MEMORANDUM TO: Mayor and City Council
Planning Commission

SUBJECT: Second Supplemental Staff Analysis:
Application SDP-7712-2017
(Kentlands Square Infill Sites, 84-96 Main Street)

SDP Second Revised Rendered Site Plan, Exhibit #100

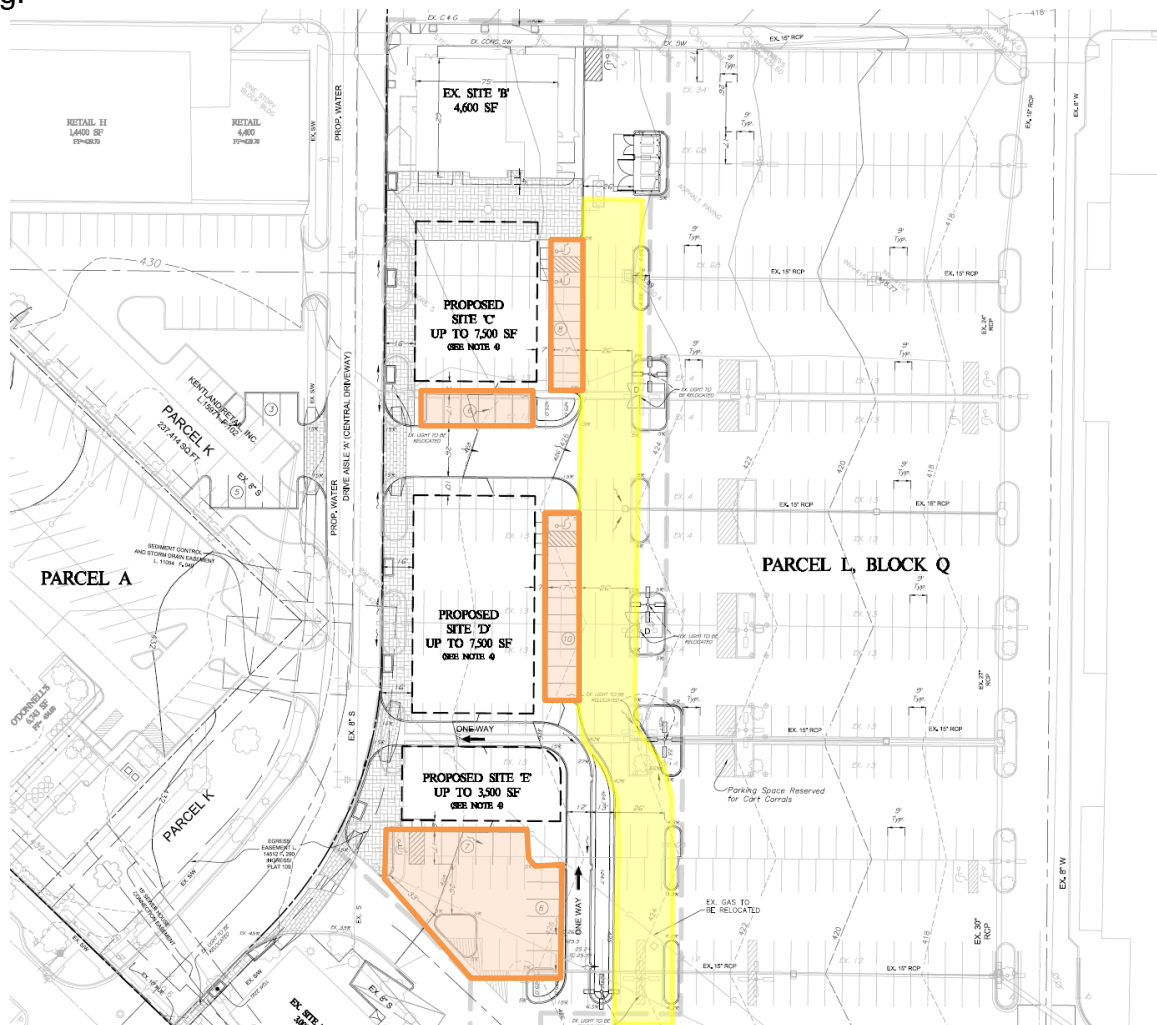
On May 15, 2018, the applicant submitted a second revised site plan with a modified drive-thru layout for Site E.¹³ On May 16, 2018, the Planning Commission voted to close its record on SDP-7712-2017 at 5 PM on May 25, 2018, and scheduled its recommendation on the revised plan for its June 6, 2018 meeting.

At the time of the Planning Commission's record closing on May 25, 2018, there are 101 exhibits in the record. Following the submission of the May 15 revised site plan layout, the applicant submitted a full revised set of plans for the Schematic Development Plan (SDP) on May 25, 2018,¹⁴ which replaces the May 15 submission. The May 25 SDP set includes a correction to the limits of the SDP, to reflect the changes made to the adjacent secondary drive aisle. In addition to the revised SDP plan set, the Applicant and design team have submitted a

SDP First Revised Site Plan, Exhibit #61 (with secondary drive aisle and adjacent parking highlighted)

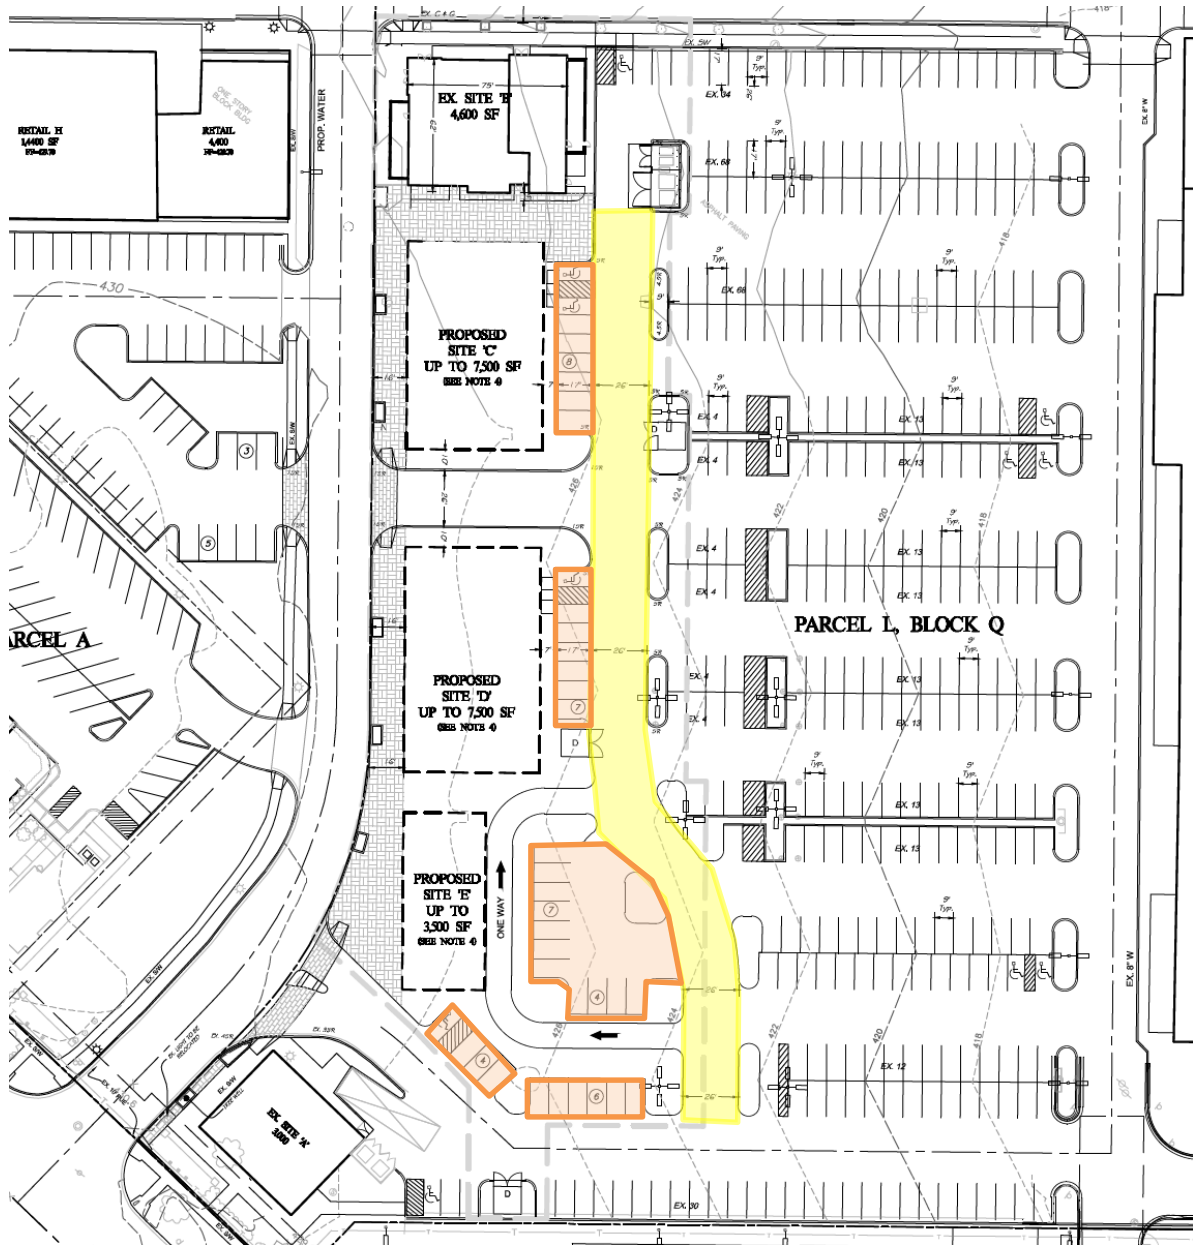
As stated, the Applicant submitted an application seeking to establish a new schematic development plan for this portion of the automobile-oriented shopping center, to make minor site changes, and to add three additional commercial infill sites totaling 16,000 square feet, in accordance with § 24-160D.9.(b). The initial plan¹⁶ showed the drive-thru lane for Site E crossing the new pedestrian way along the private central drive aisle. While the first revised plan¹⁷ showed the drive-thru lane avoiding this crossing by being re-located to the rear of Site E, the drive-thru lane did separate some of the parking in close proximity to the proposed building.

SDP Second Revised Site Plan, Exhibit #99, Sheet 2

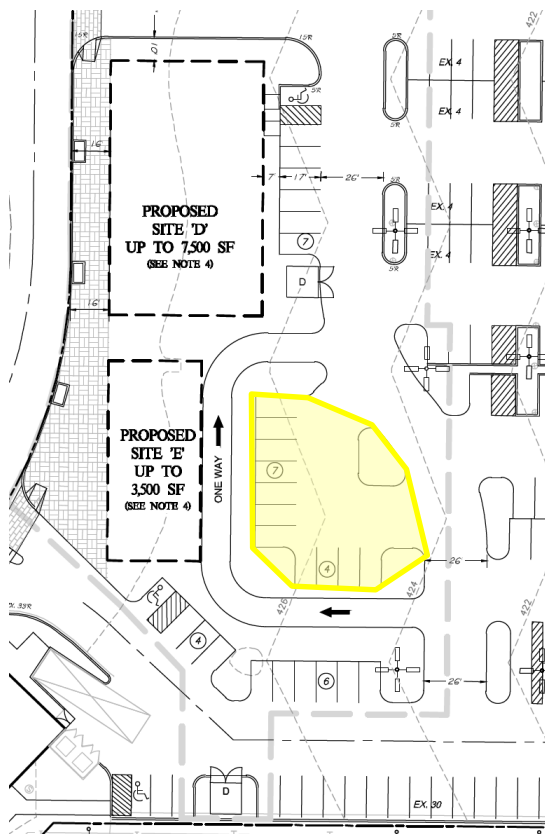
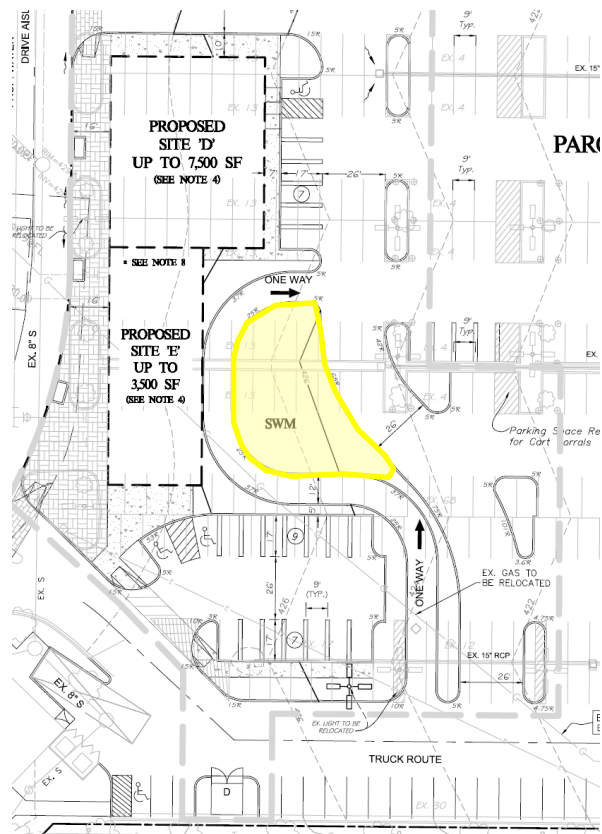
The current revised plan¹⁹ being reviewed maintains the drive-thru location to the rear of Site E, but the relocated drive-thru lane avoids both the central drive aisle and the parking area adjacent to the proposed building, which helps to separate Site E operationally from the other Sites. This “operationally independent” aspect of Site E’s current redesign directly addresses the Council’s concerns about potential traffic conflicts and pedestrian crossings from the parking lot, as the drive-thru has been further isolated from pedestrians, adjacent parking, and other traffic circulation routes. Specifically, the drive-thru meets the best practices of the

Technical Memo presented to the Planning Commission,²⁰ as the drive-thru lane is located to the service side of the building rather than the primary frontage, does not connect to the public street or primary central drive aisle, is separated from parking and other drive aisles by a curb, has a stacking length of 200 feet that can accommodate ten cars, and has its access point located well away from the major nearby intersections. Additionally, the redesigned configuration physically separates the associated customer parking from the drive-thru lane, eliminating the likelihood that customers will need to walk across the drive-thru lane to reach Site E. Lastly, access to the adjacent parking is via one entrance only and the area adjacent to the drive-thru lane (highlighted in yellow below) has been changed from parking spaces to landscaping and stormwater management, further reducing potential pedestrian conflicts.

The current site plan design retains the secondary drive aisle in the parking lot (highlighted on the next page) and the features of the first revised plan for Sites C and D, but includes changes for Site E. Specifically, the build-to line for Site E has been extended northward and the drive-thru lane has been re-routed to avoid the nearby convenience parking. The larger larger build-to line for Site E is necessary to allow additional flexibility in the placement of the drive-thru window, while allowing the drive-thru lane to meet the minimum best practices standards²¹ of stacking for ten cars and a length of 200 feet. Although the current site plan design shows the build-to lines for Sites D and E abutting each other, Note 6 on the site plan confirms that there will be a separation between the buildings, to be determined at final site
